**JURUPA COMMUNITY SERVICES DISTRICT
RIVERSIDE, CALIFORNIA**

ADDENDUM NO. 4

**TO THE PLANS AND SPECIFICATIONS FOR
RECYCLED WATER PROGRAM – SEGMENT 3 FINAL DESIGN
JCSD P.N. C215078**

NOTE: DEEP WATER SERVICE CONNECTION SHALL BE PER JCSD STD. DWG. R/NP-10B

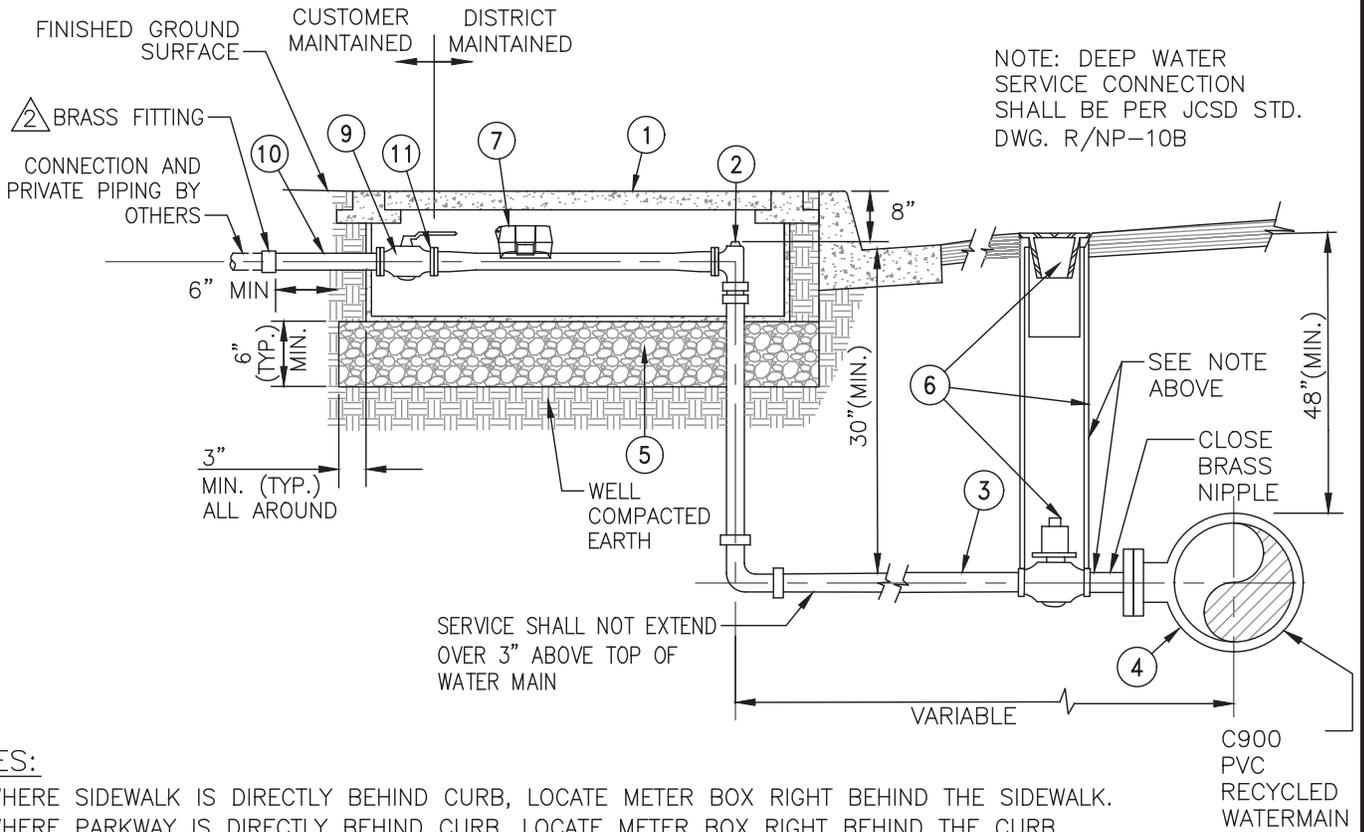
1. Appendix K has been modified to include updated Standard Drawing details for R/NP-8, -8A, -8B, -9, -9A, -9B, -10, -10A, -10B, and -10C. The updated Appendix K section has been included in its entirety in **Attachment C**.
